Report of the CAA's Post Implementation Review of Birmingham International Airport Airspace Change Proposal – Runway 15 Southerly RNAV-1 Standard Instrument Departure Procedures

CAP 1792

Published by the Civil Aviation Authority, 2019

Figure 1: Comparison of mean departure tracks for trial and post implementation

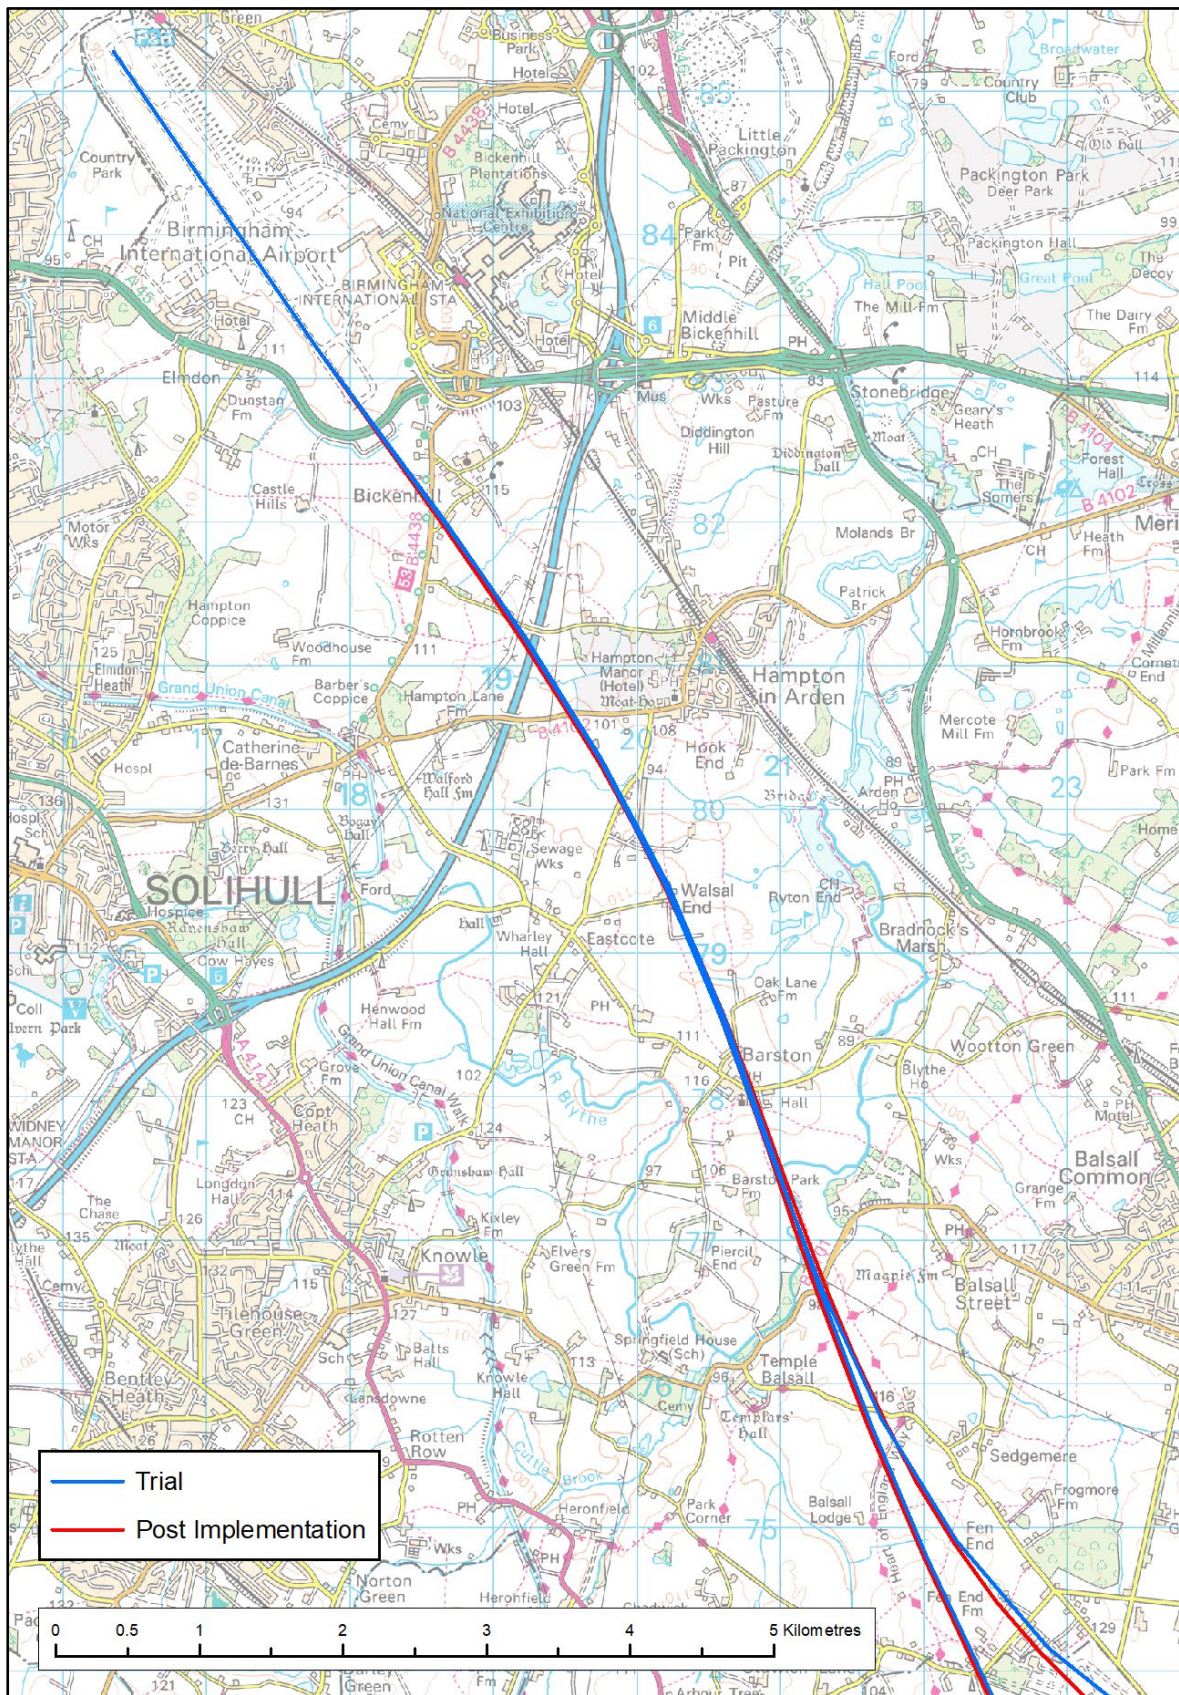
57. **Figure 1** (on the following page) presents a comparison of the mean departure tracks calculated from the trial and post implementation radar data relating to locations of Barston and Balsall Street East. The post implementation mean track shows very close agreement with that from the trial.

Figure 2: Gate analysis overhead Barston

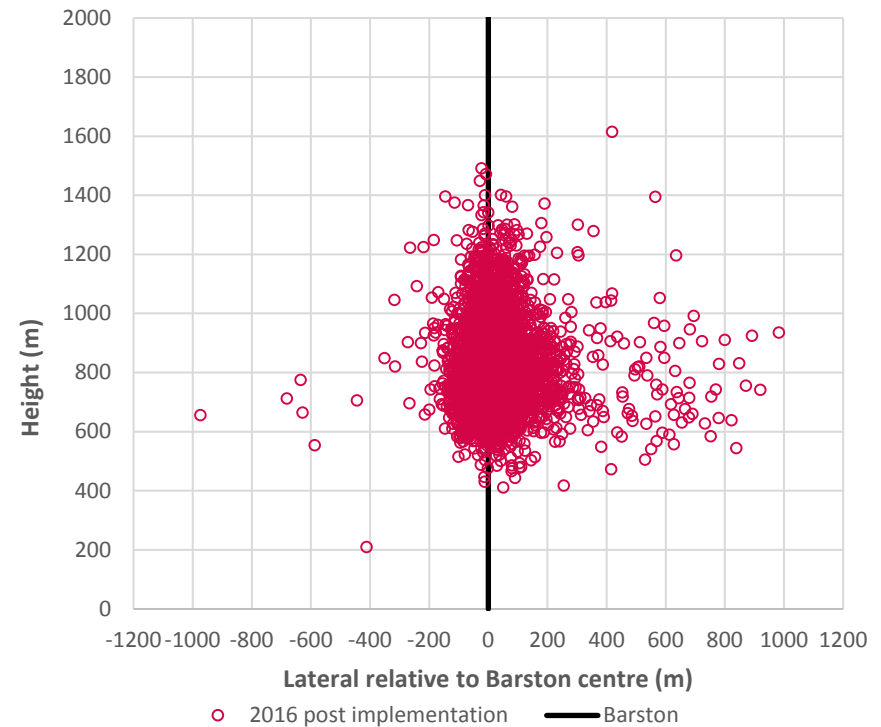
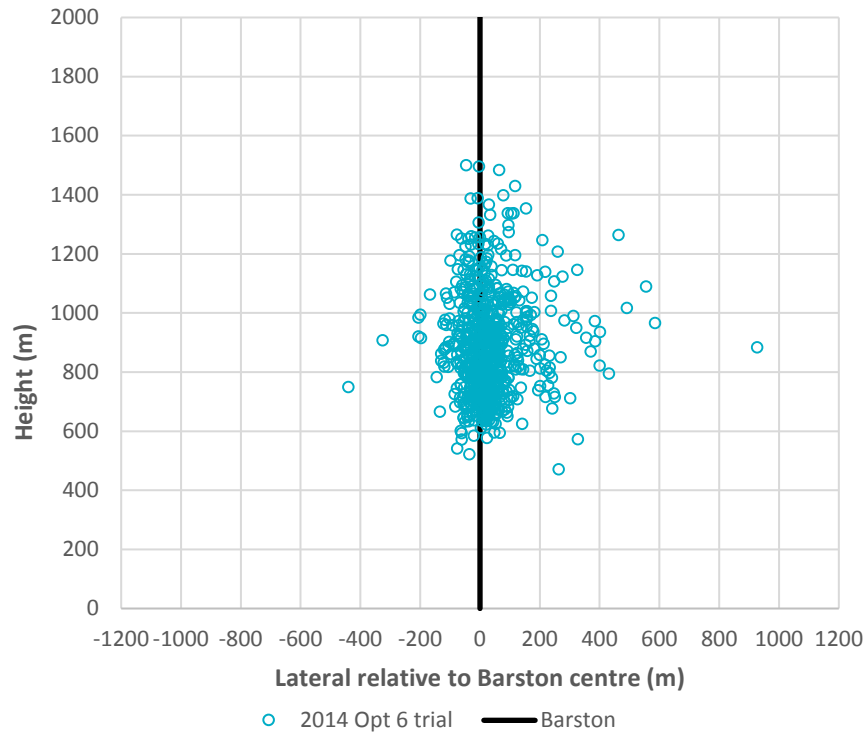
Figures 2 and 3 (below) break down the track position and aircraft height analysis into gate plots showing aircraft position relative to overhead Barston and Balsall Common. Since data for post implementation from 2016 covers three months, rather than the trial period of one month, the data are plotted separately. Whilst there is greater variation within the post implementation data, because it covers much greater seasonal weather variation, it is clear that track positions are consistent with the trial route option 6.

In diagram 2, the position of aircraft flying the approved RNAV-1 SID during the post implementation period in 2016 is shown by the red circles in both the lateral displacement from Barston and in the vertical plain in relation to altitude in metres above Birmingham aerodrome runway level. The main core of the departures is just to the east of the centre of Barston village although departures are still also flying to the west of the village; the altitude of departures is mainly above 500m as they pass Barston.

Figure 4: Departure height profiles for Ryanair Boeing 737-800 aircraft during the two trial periods and post implementation. Error bars show the 95% confidence interval about the mean height.

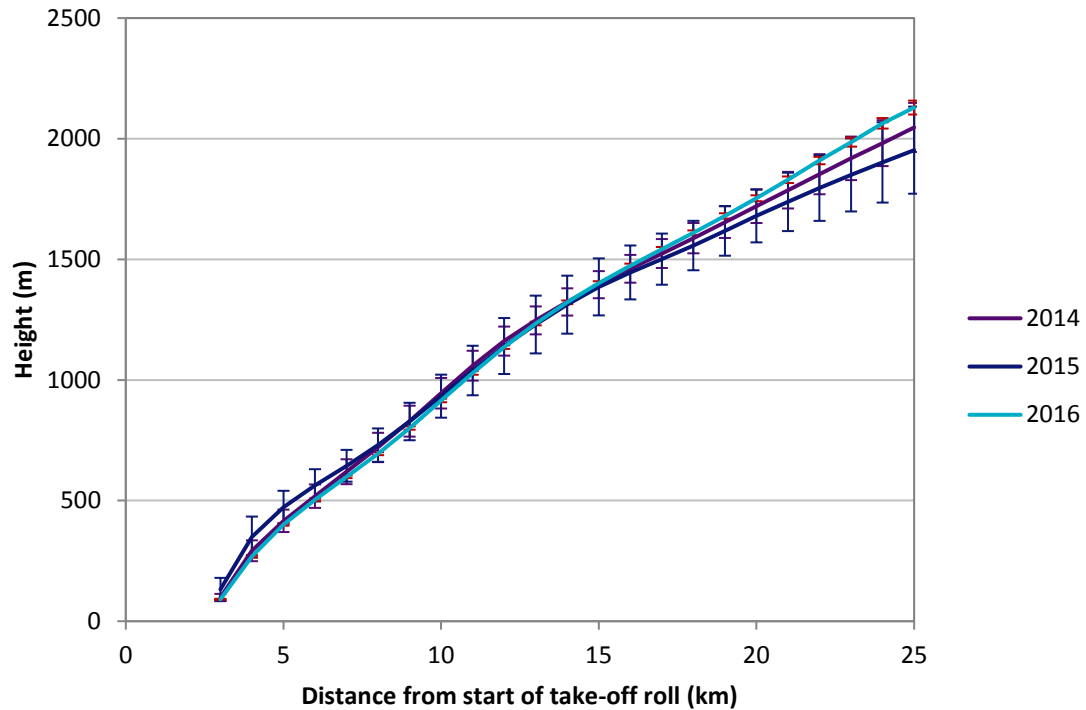
58. It is, however, apparent that the average aircraft height after departure has reduced since the trial. We have concluded that this is due to changes in the type of aircraft operating and not due to the airspace design. First, the trial data provided was from January 2015 and thus included fewer operations by charter airlines that operate more intensively during the summer period. For example, Airbus A320 family aircraft made up 31% of the summer 2016 data sample, but only 4% of the January 2015 sample. Secondly, Flybe who operated the single most dominant type in January 2015, the Embraer ERJ 170 (36% of ops) operated an approximate equal mix of the ERJ 170 and Bombardier Dash 8 Q400 turboprop during summer 2016.

59. In order to make a consistent comparison, the most dominant type of operating during both the trial and post-implementation period, the Boeing 737-800, was analysed in detail. Previously the dominant 737-800 operator was KLM operating the 737-800 to Amsterdam, a short route of 240nm distance from Birmingham. In summer 2016, Ryanair was the dominant operator operating to a range of central, eastern and southern European destinations, an average distance of 900nm from Birmingham. The longer distance and higher fuel load consequently result in Ryanair departure heights being lower than those of KLM. Comparing the largest common sample of Ryanair Boeing 737-800 departures, we can assess whether the airspace change has had any impact on departure heights. Comparing Ryanair Boeing 737-800 height profiles between both trials and the summer 2016 post implementation data we find the mean heights are statistically the same (see **Figure 4** below). Thus, in our view the airspace design has not itself contributed to the reduction in aircraft height.

Fig 1. CAA diagram to show 4000ft waypoints.

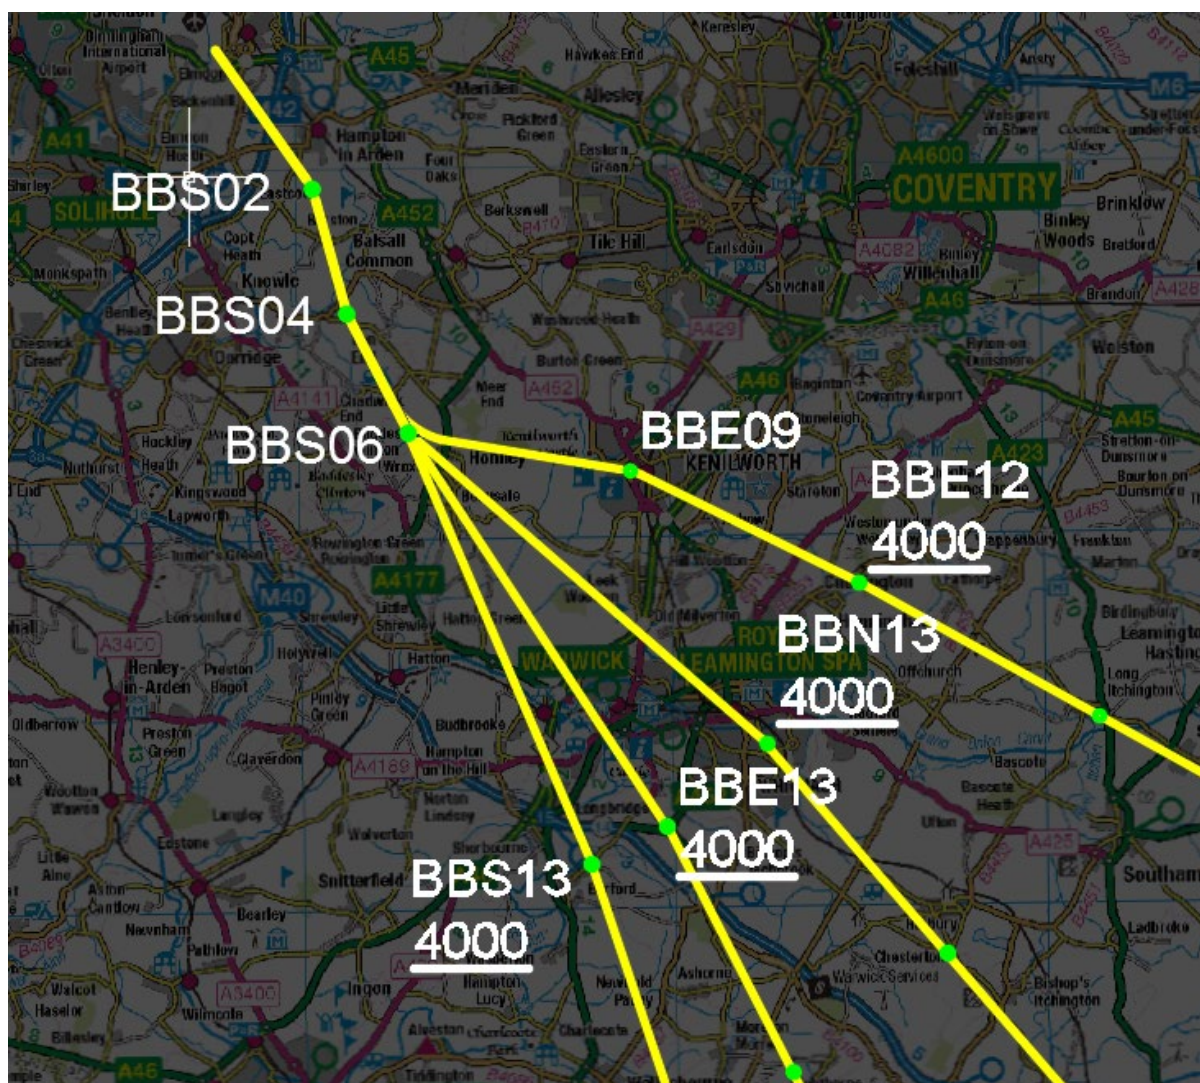
15. Whilst we have determined that the lateral track keeping of departures is as the procedure designs intended, from the track data provided in the up to 4000ft track dispersion diagrams and the 4000ft-7000ft diagrams, it was straight forward to determine if the vertical profile was being achieved without annotating the 4000ft waypoints onto a separate chart, and then comparing the waypoint positions with the track dispersion diagrams. The CAA therefore provides two sets of diagrams to show the location of the 4000ft waypoints (see Figs 1 and 2 below) to enable comparison of waypoints against the track dispersion plots in order to demonstrate whether the vertical profile was being achieved.

The 4000ft waypoints are located at positions BBE12 (DTY2Y), BBN13 (WCO2Y), BBE13 (COWLY2Y), and BBS13 (CPT2Y).

For other departures following the WCO, COWLY and CPT '2Y' SIDs, all departures are reaching 4000ft by Wroxal which is just after position BBS06. BBN13 and BBE13 are located 6.9NM after BBS06, and BBS13 is located 6.8NM after BBS06, therefore the designed vertical profile is being achieved.

Fig 2. CAA diagram to show 4000ft waypoints.

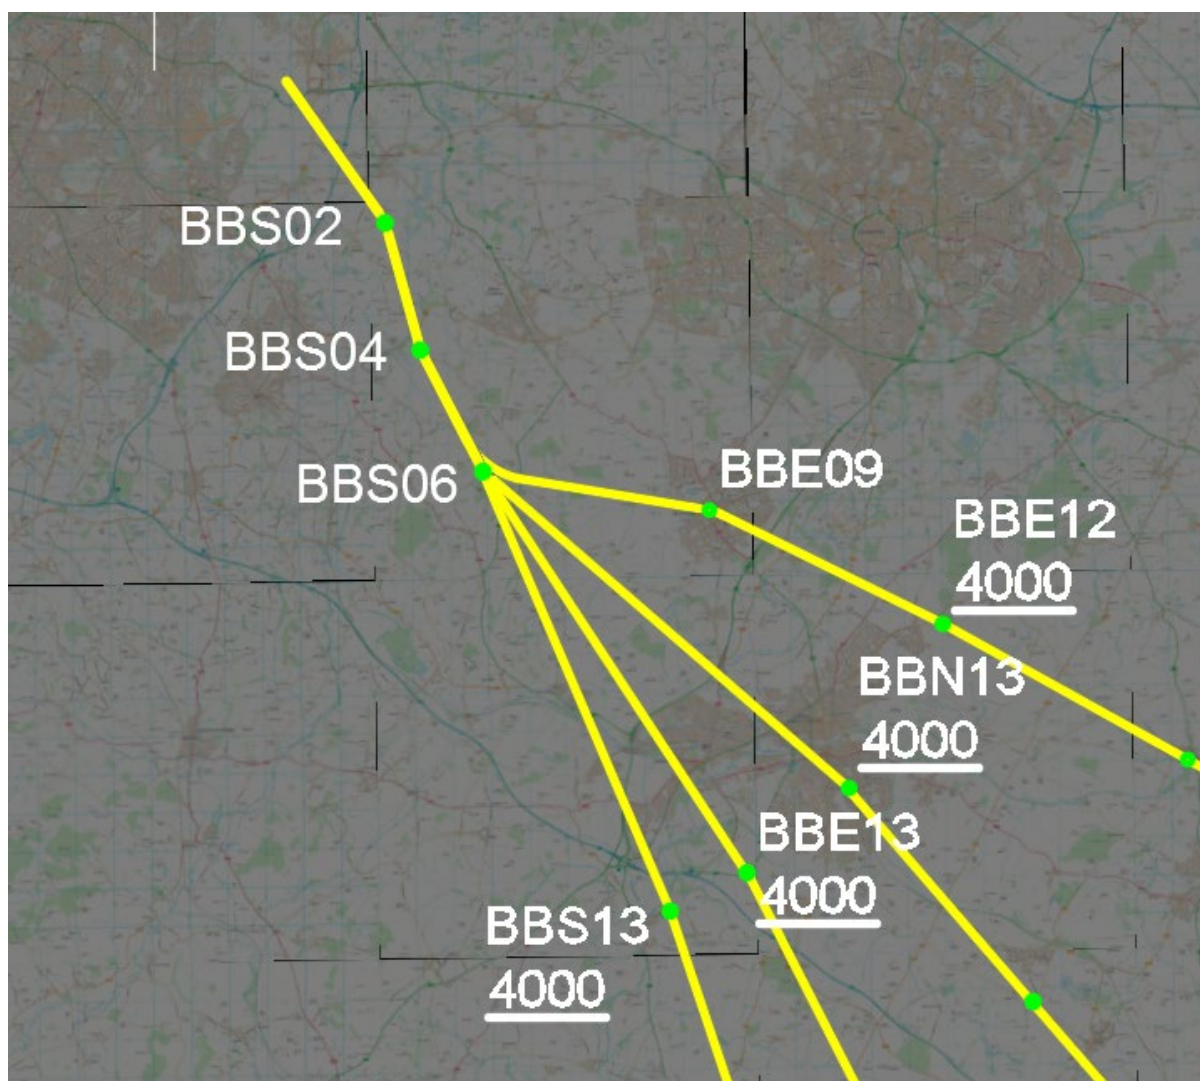
In Fig 2 below, a different expansion is shown to illustrate the same waypoint location for interested parties.
